## COMMUNITY SERVICES DEPARTMENT

**Subject: Springs at Waterview Rezone (P-17-017)**

### Springs at Waterview Development Application Review

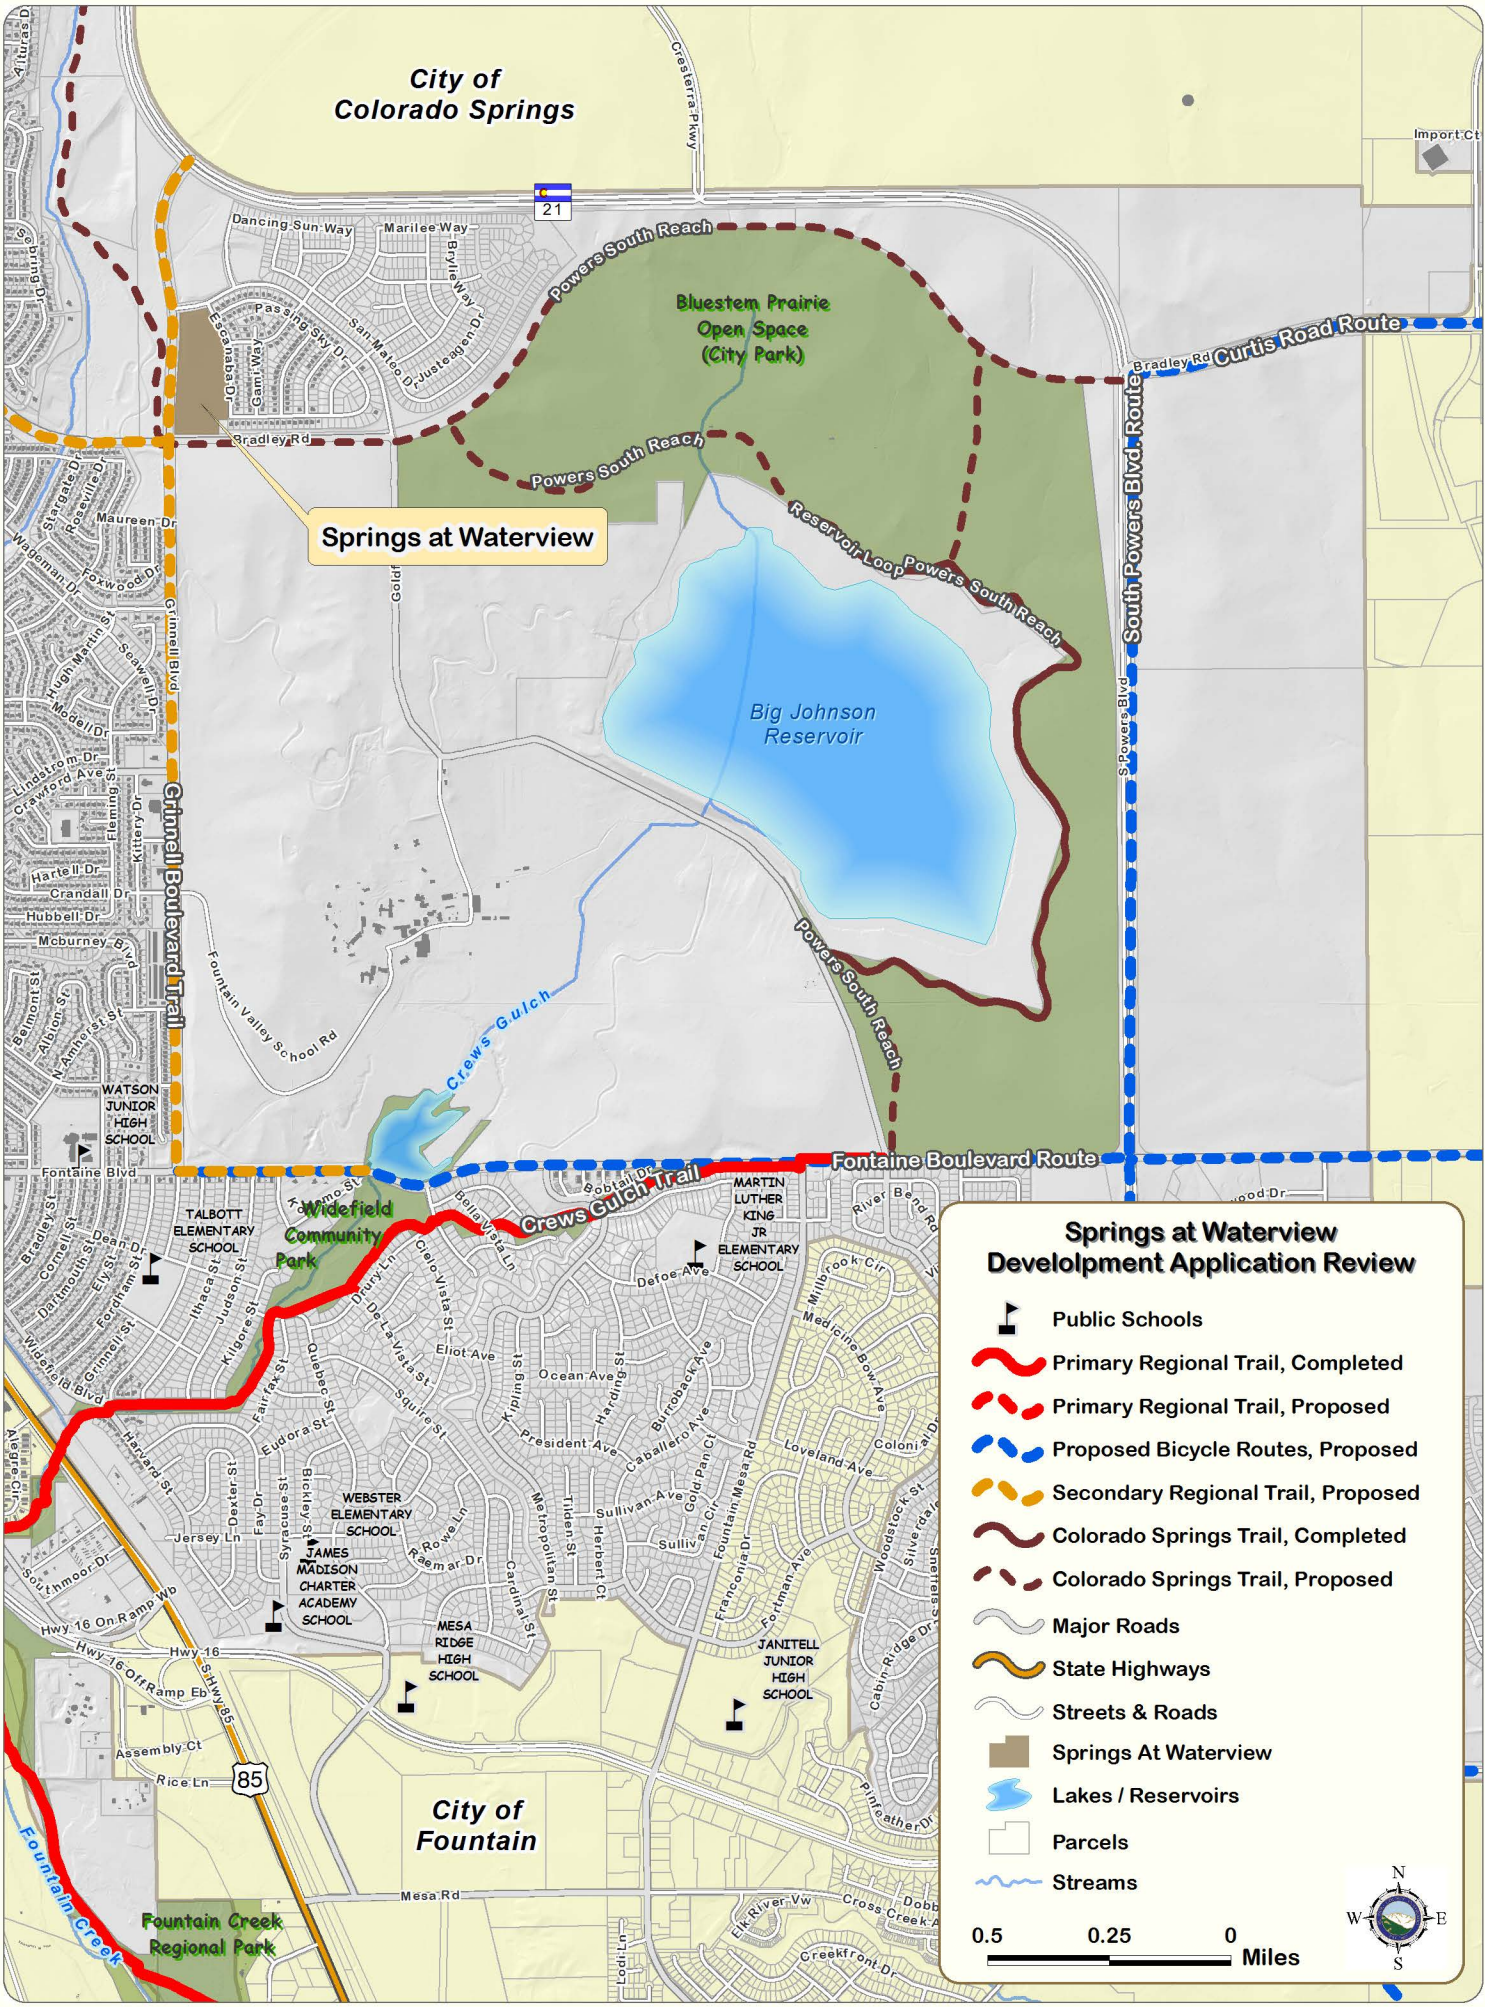
*The current Preliminary Plan and Final Plat applications do not show the trail easement on the west side of Grinnell Boulevard north of Bradley Road, nor is there mention of the trail easement in the Preliminary Plan or Final Plat general notes or letters of intent. As such, El Paso County Parks recommends that Springs at Waterview Preliminary Plan and Final Plat (1) designate and provide to El Paso County a 25-foot trail easement along the west side of Grinnell Boulevard, north of Bradley Road to Powers Boulevard, that allows for public access, as well as construction and maintenance by El Paso County of the Grinnell Boulevard Secondary Regional Trail, (2) show the easement on the Preliminary Plan and Final Plat, and dedicate the aforementioned easement to El Paso County prior to the recording of the Final Plat, (3) and pay fees in lieu of land dedication for regional and urban park purposes at time of the recording of the Final Plat.*

*show on the Final Plat and dedicate to El Paso County a 25-foot trail easement along the west side of Grinnell Boulevard, north of Bradley Road to Powers Boulevard, that allows for public access, as well as construction and maintenance by El Paso County of the Grinnell Boulevard Secondary Regional Trail, (2) require fees in lieu of land dedication for regional park purposes in the amount of \$31,339 and urban park fees in the amount of \$19,789.”*
